## Product Change Notification

### PCN-ICC-4468-2019

Business Unit	Product Line Code	Type of Change	Action	Date of Issue
ICC - Industrial Cabinet	BE2	Product Change Notification	Notify Distributors and Field	11/4/2019

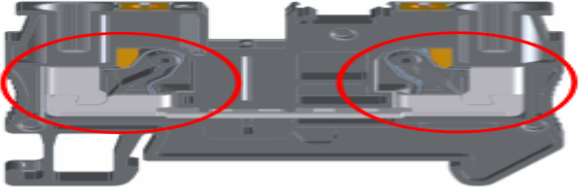
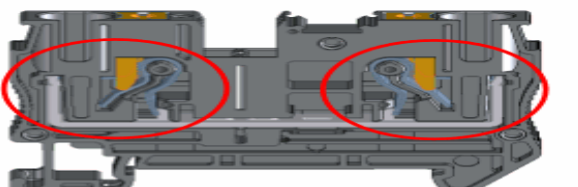
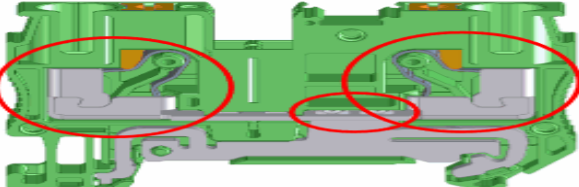
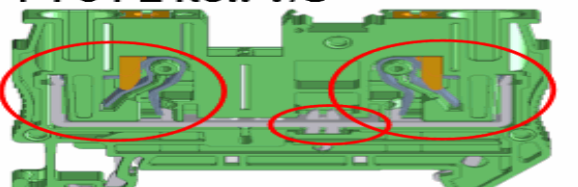
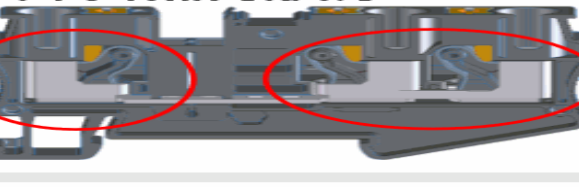
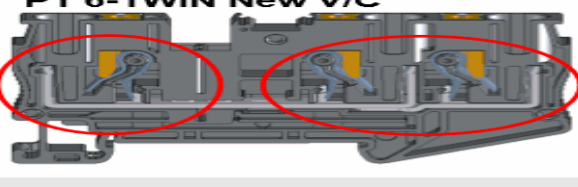
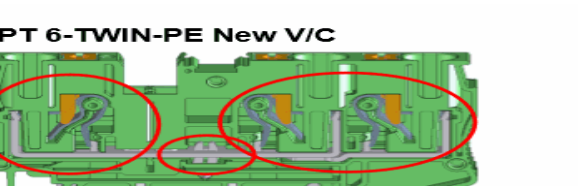
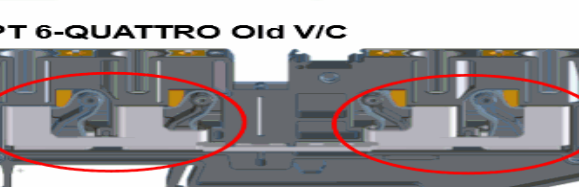
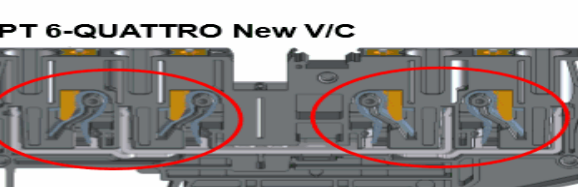
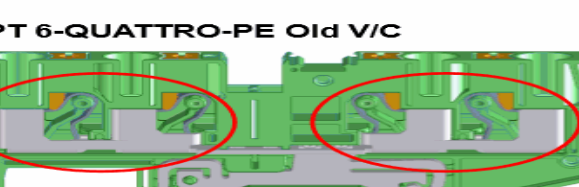
The push-in conductor connection is being changed over to the now familiar "L" shaped current bar. Technical parameters such as current, voltage, approvals, accessories, etc will not change. The PE foot in the -PE versions will now be pressed into the current bar.
